Item 4.**Development Application: 499-501 Kent Street, Sydney - D/2019/969****File No.:** D/2019/969**Summary**

Date of Submission: The application was lodged with Council on 30 August 2019. Amended plans and documentation were submitted on 12 March 2020.

Summary Recommendation: This proposal is recommended for refusal.

Figure 19: Typical tower floor plan

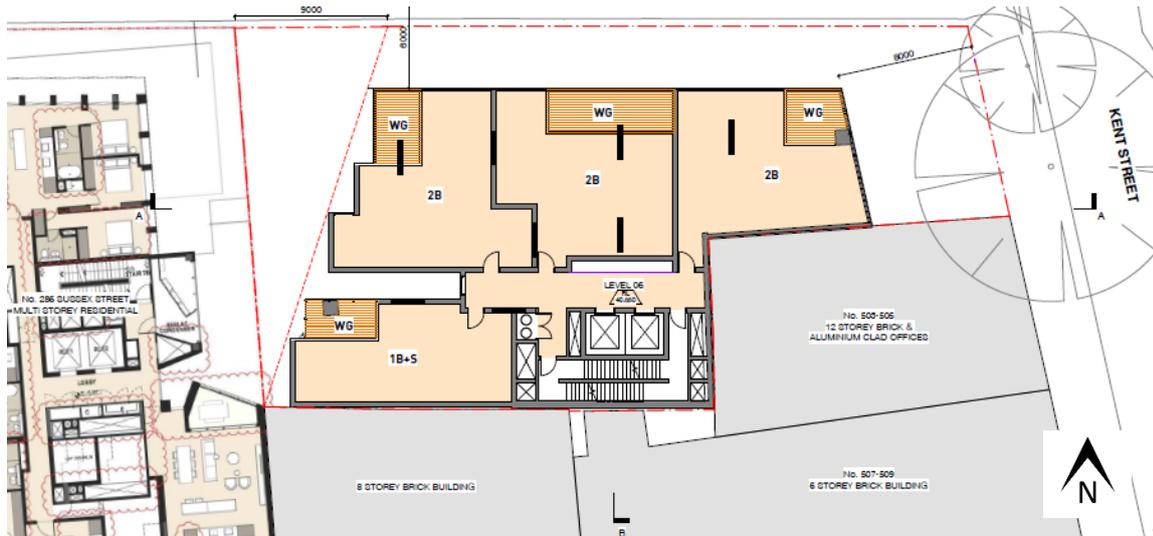
- In the tower, the minimum separation distance should be 12m. However, as per Figure 19 below, between 1.9m and 9m is provided. This results in both the apartments to the western boundary on a typical floor (L4-L8) having single aspect apartments with solid walls to the west.

- The blank walls to the west indicate that there are still insufficient ADG separations between residential buildings across the western boundary. The blank walls are there to mitigate the visual and acoustic privacy impacts.

47. Council acknowledge that the adjoining western property, 60 Bathurst Street, encroaches on the separation requirements. However, at the time of the assessment of that application, the non-compliances were considered appropriate given the subject site's heritage status and the unlikelihood of a residential tower being developed.

Figure 20: Indicative section. Large portion of common open space that is essentially 'roofed' circled.

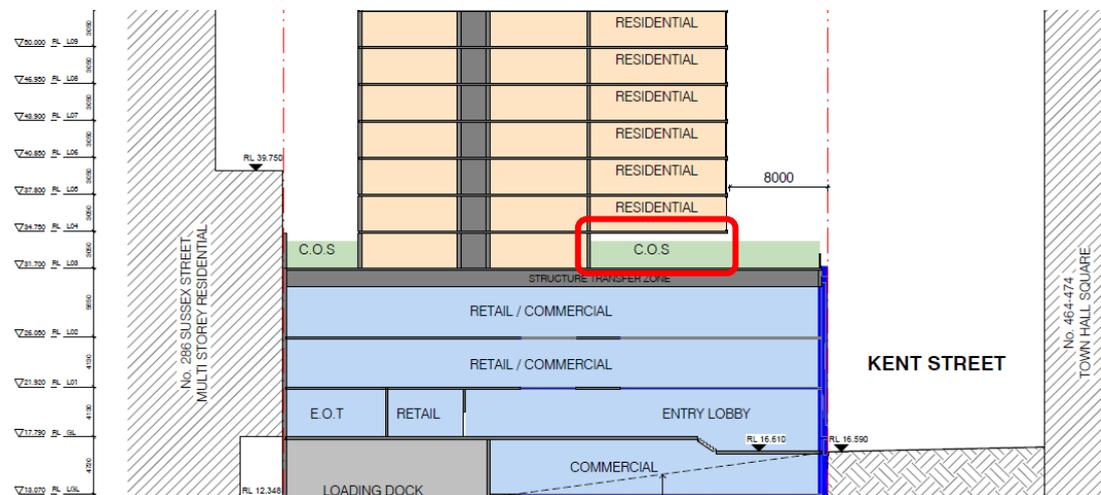
- (a) a large portion of the front communal open space area being covered by the level above, as shown in Figure 20 below. This significantly reduces the amount of direct sunlight received to this area and essentially reduces the 'openness' of this space.

Figure 21: Indicative Level 3 plan. Approximate area undercover shaded in red.

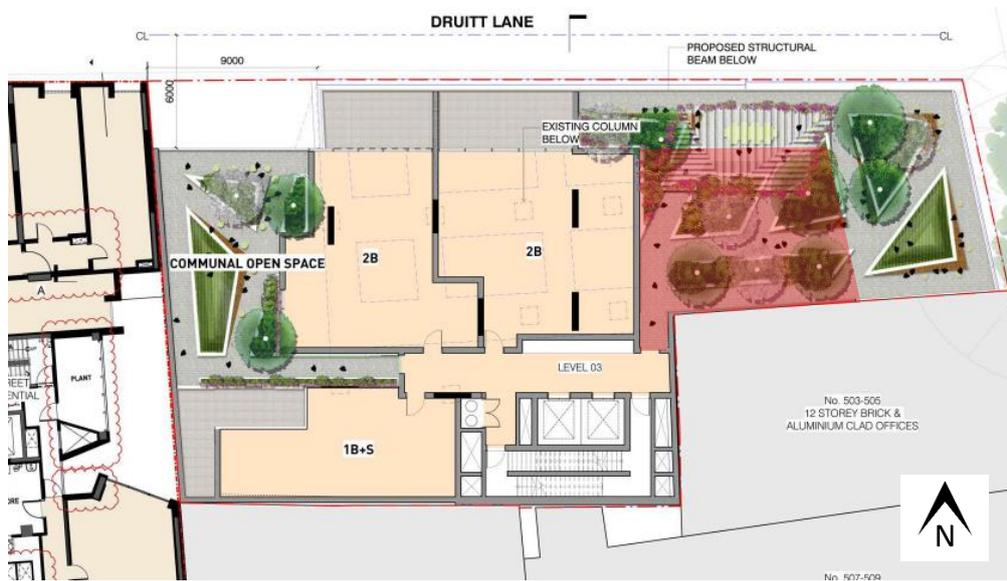
- (b) Issues also arise with the proposed common open space to the west, with privacy issues with the western apartments on Level 3, which directly adjoin the common open space area. Additionally, a tall 3m wall is proposed to be built to the western boundary to mitigate privacy impacts with the adjoining property to the west, which is not an amenable outcome in terms of outlook and sunlight. Please refer to Figure 21 below.
